Addendum No. 1
for Construction of
Water Pump Station
for the
CAGLE-FREDONIA UTILITY DISTRICT
in
SEQUATCHIE COUNTY, TENNESSEE

CONTRACT 125 – WATER PUMP STATION – JOHN HENRY LEWIS ROAD

Date: July 15, 2025
Bid Date: July 24, 2025
Bid Time: 2:00 P.M. LOCAL TIME

PLAN AND SECTIONS
JOHN HENRY LEWIS RD.
PUMP STATION

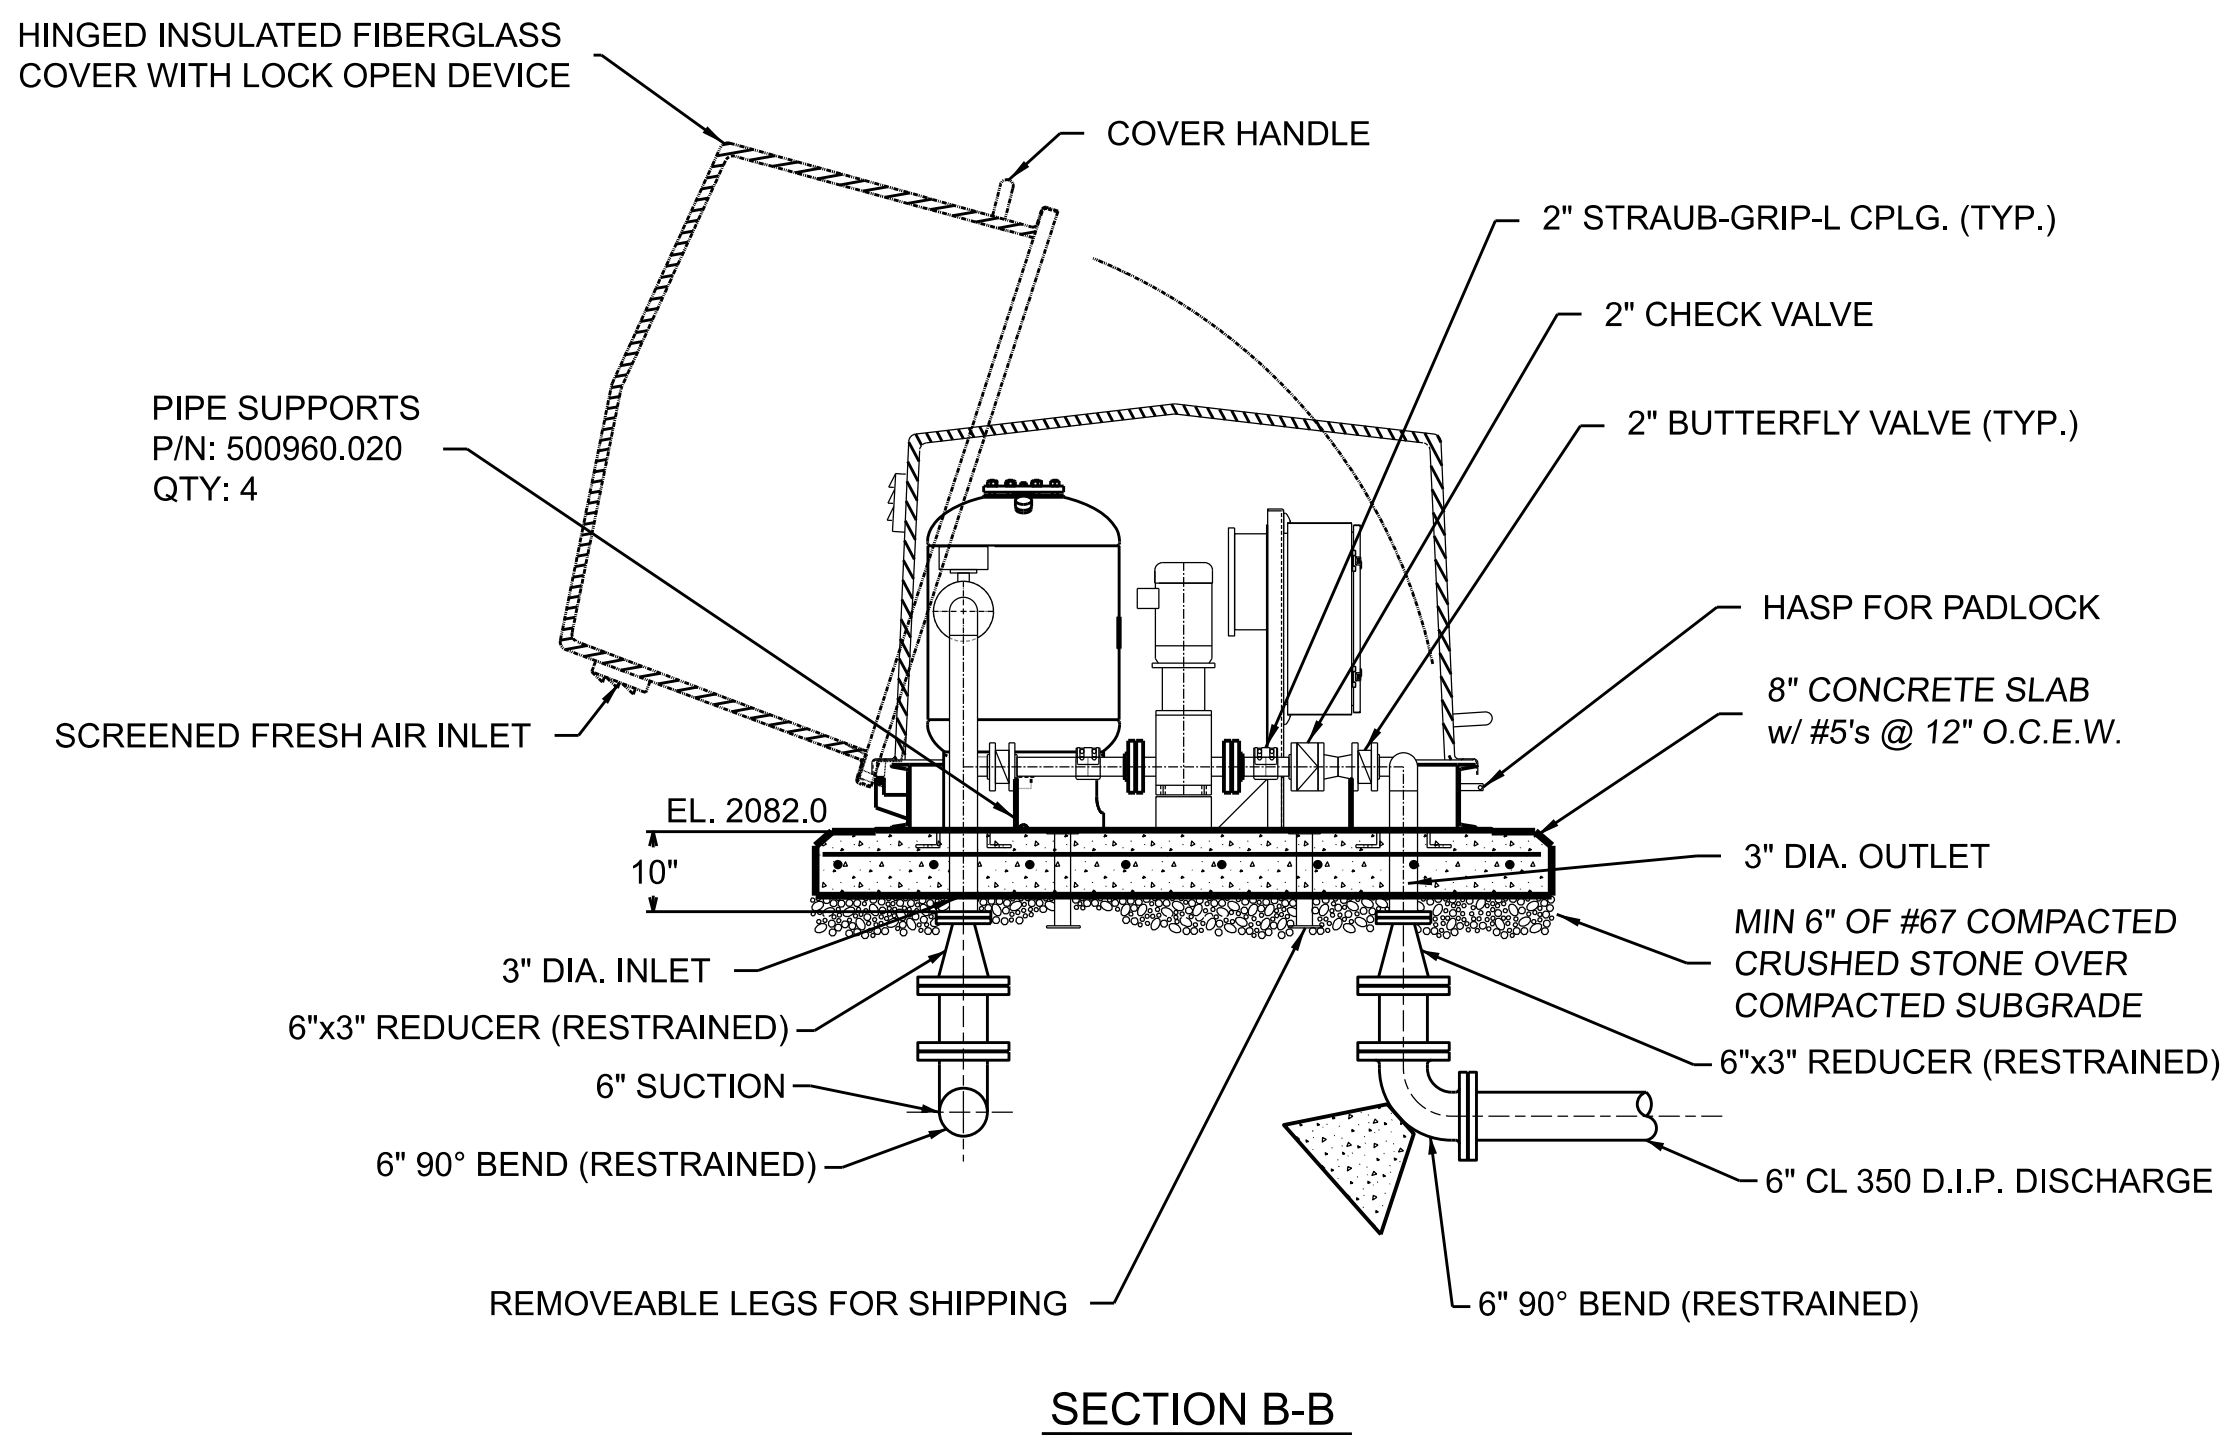
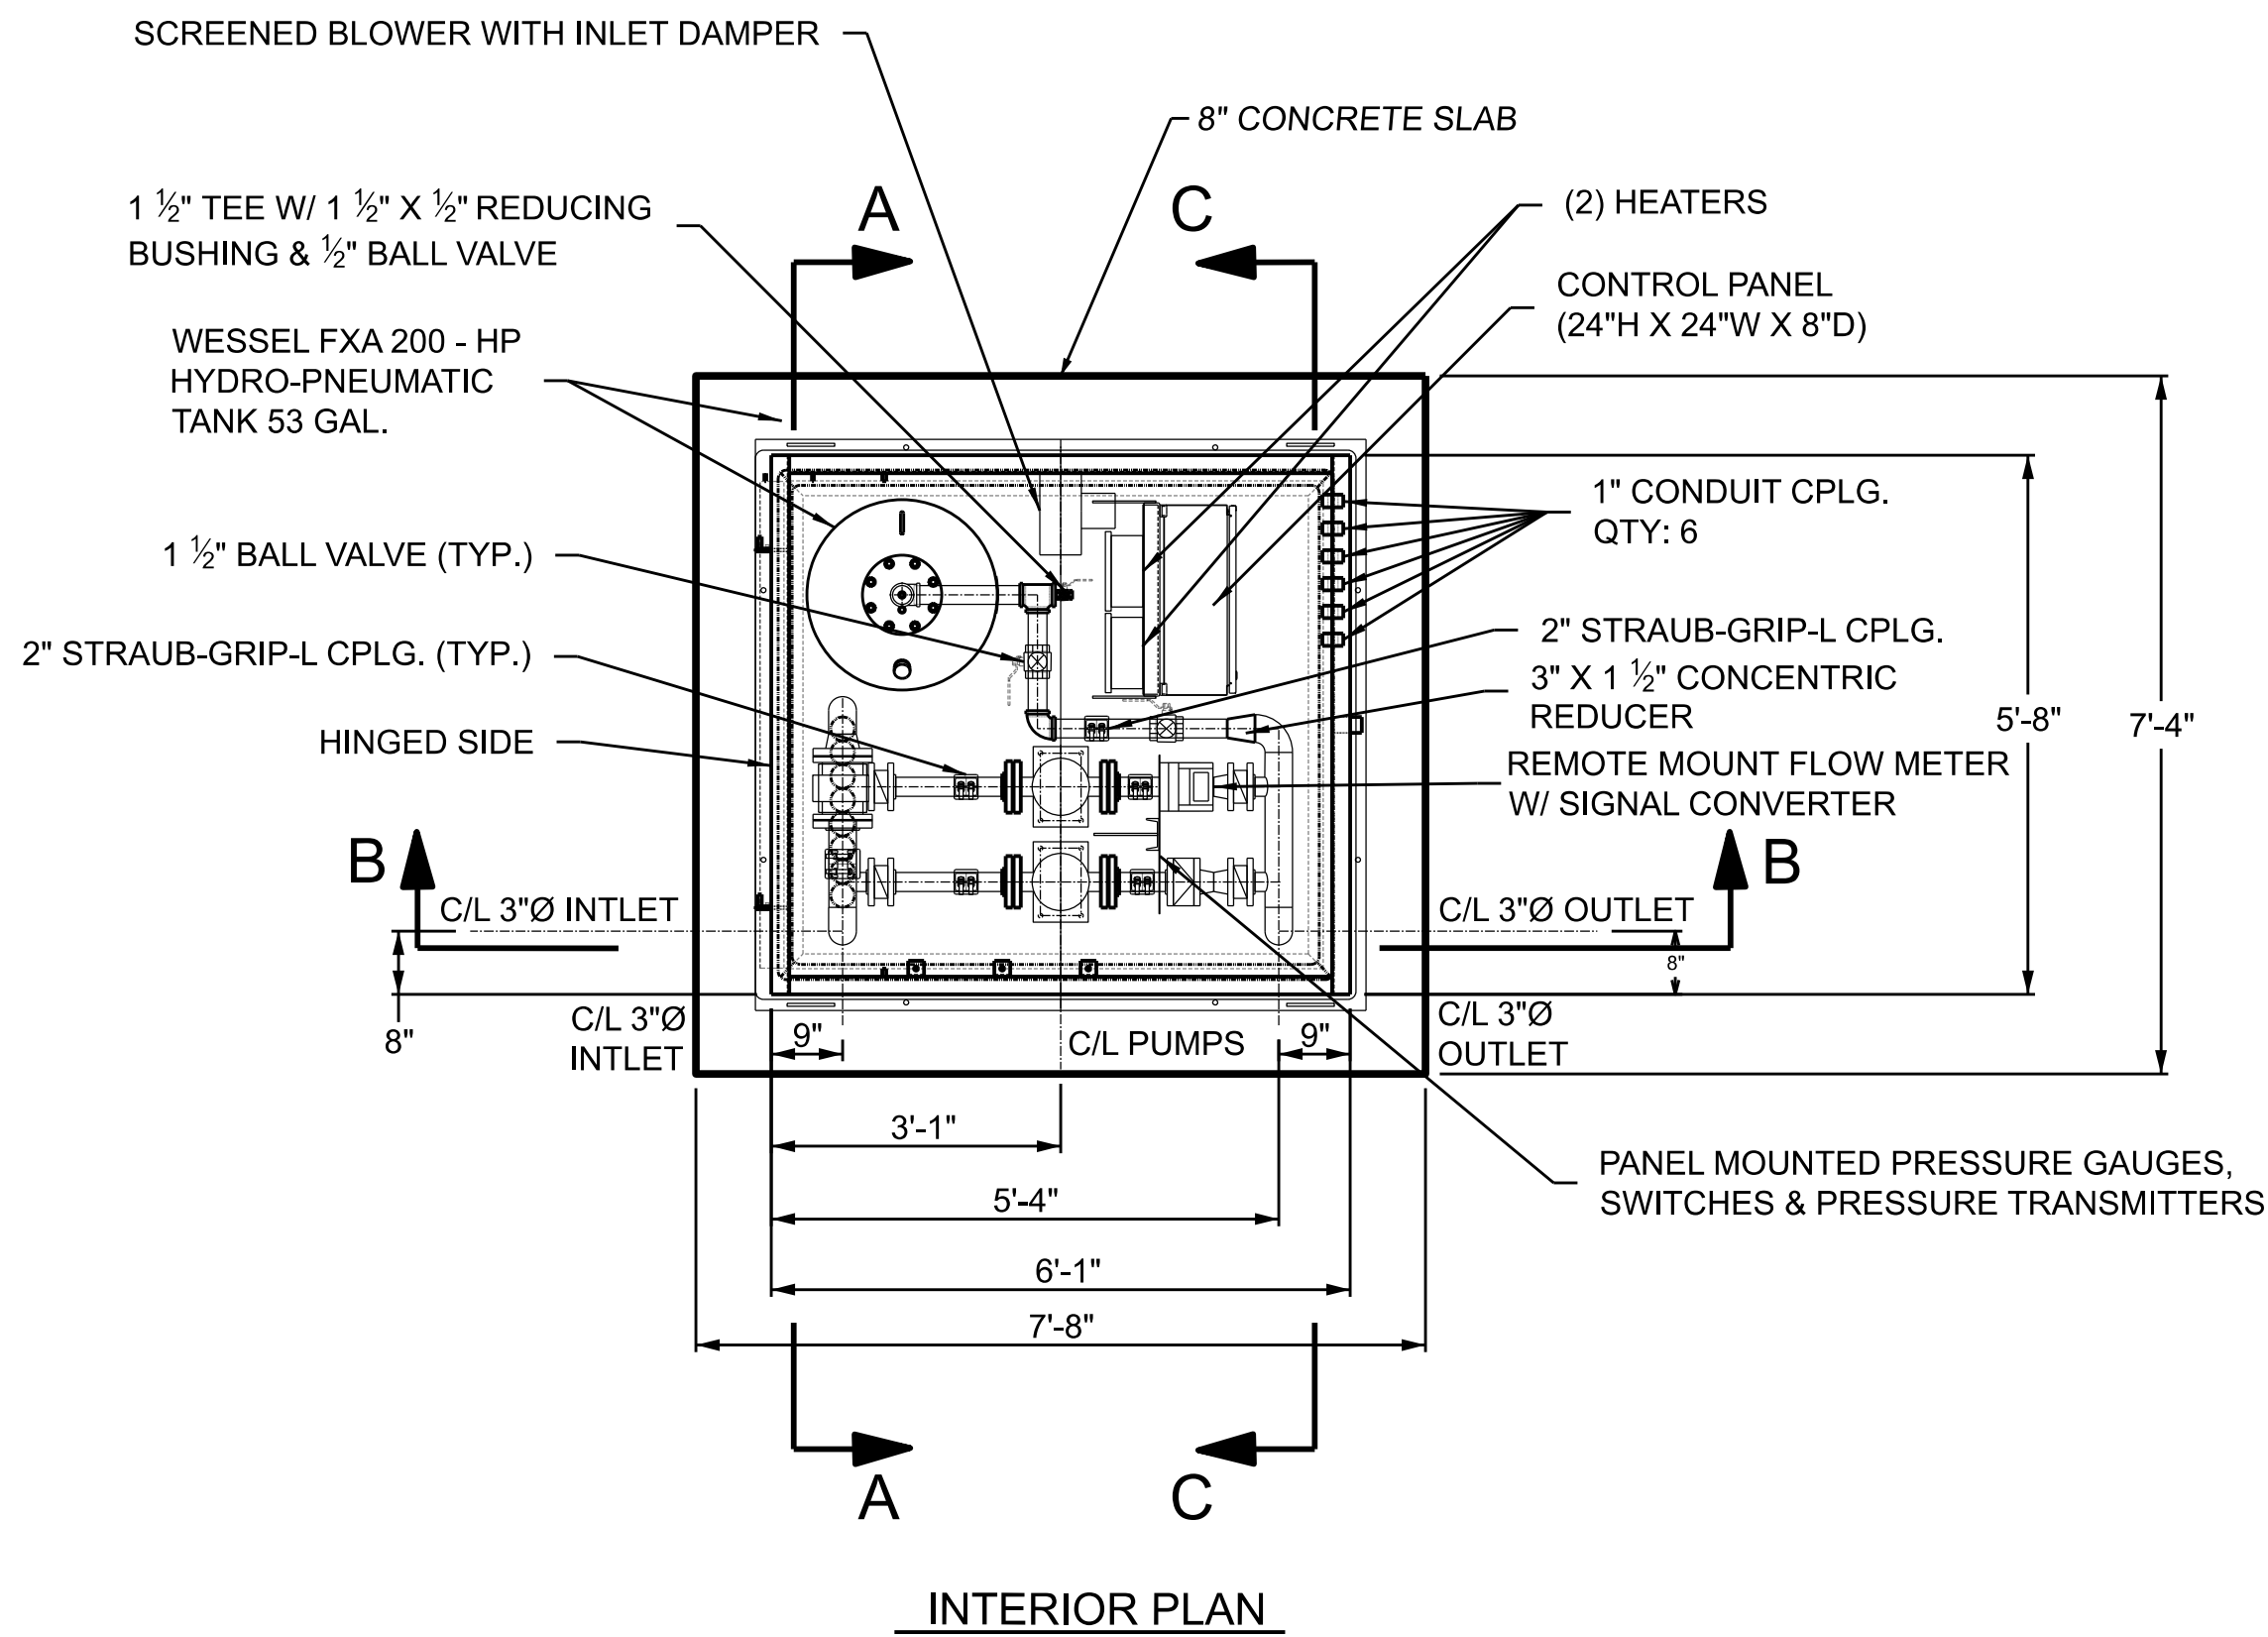
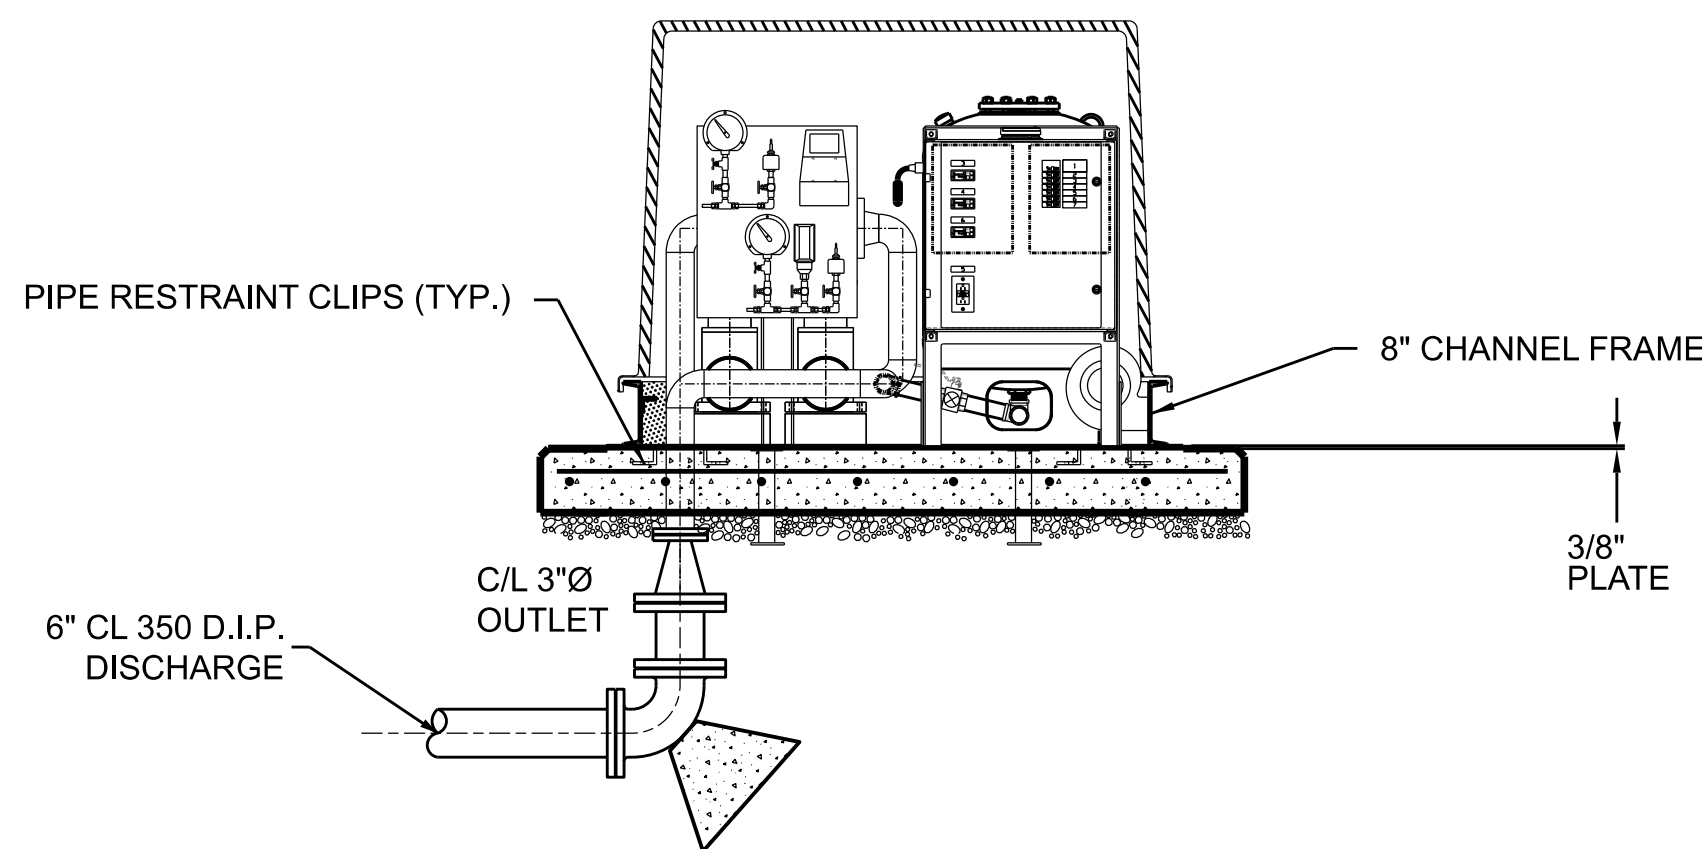
PLANS: Replace Sheet 3 with attached Sheet 3, the following items have been updated:

- General Note 5.
- Design Criteria - “Controls”.
- Revised note for “panel mounting” on Interior Plan View.

- STATION PIPING: INTERIOR STATION PIPING TO BE SCHEDULE 40 STEEL. ALL PIPE TO HAVE HEAT TRACE TAPE.
- STRUCTURAL STEEL: STRUCTURAL STEEL SHALL MEET ASTM A-36. STRUCTURAL TUBING SHALL MEET ASTM A500, GRADE B.
- PAINTING: CAPSULE AND STRUCTURAL STEEL SHALL BE PAINTED WITH 6MILS DFT OF TNEDEC SERIES N69. SURFACE PREPARATION SHALL BE IN ACCORDANCE WITH MANUFACTURER'S RECOMMENDATIONS. INSIDE OF STEEL PIPE TO BE TRIPLE FUSION COATED.
- DO NOT SHIM STATION. CONCRETE SLAB TO BE CONSTRUCTED LEVEL ON FIRMLY COMPACTED BASE MATERIAL.
- PRESSURE GAUGES: EACH PUMP SHALL HAVE A STANDARD PRESSURE GAUGE ON ITS DISCHARGE LINE AND A COMPOUND GAUGE ON ITS SUCTION LINE. GAUGES SHALL READ AS FOLLOWS:

SUCTION - 0 - 30 in. Hg / 0-160 psi
DISCHARGE - 0 - 200 psi
- TELEMETRY: CELLULAR TELEMETRY TO BE AS MANUFACTURED BY MISSION COMMUNICATIONS. TELEMETRY SHALL BE COMPATIBLE WITH THE OWNER'S EXISTING MISSION SYSTEM FOR MONITORING OF THE PUMP STATION.
- ALL EXTERIOR 6" PIPE SHALL BE PRESSURE CLASS 350 DUCTILE IRON WITH MECHANICAL JOINT DUCTILE IRON COMPACT FITTINGS. FITTINGS BELOW THE STATION SHALL BE RESTRAINED. PIPING UNDER STATION SHALL BE BACKFILLED WITH COMPACTED CRUSHED STONE.
- CONTRACTOR SHALL DISPOSE OF ALL EXCESS MATERIAL AND SITE CLEARING DEBRIS OFF-SITE.
- CONCRETE FOR SLAB SHALL BE 6.5 BAG MIX, MAXIMUM SLUMP OF 5.0 INCHES, 28-DAY MINIMUM STRENGTH OF 4,500 PSI. REBAR SHALL BE ASTM A 615 GRADE 60.
- INSTALL PUMP STATION AND EQUIPMENT PER MANUFACTURER'S RECOMMENDATIONS. PUMP STATION TO BE AS MANUFACTURED BY USEMCO, INC. TOMAH, WI OR PRE-APPROVED EQUAL.

CONTROLS: CELLULAR TELEMETRY, VFD's, ALTERNATING PUMPS
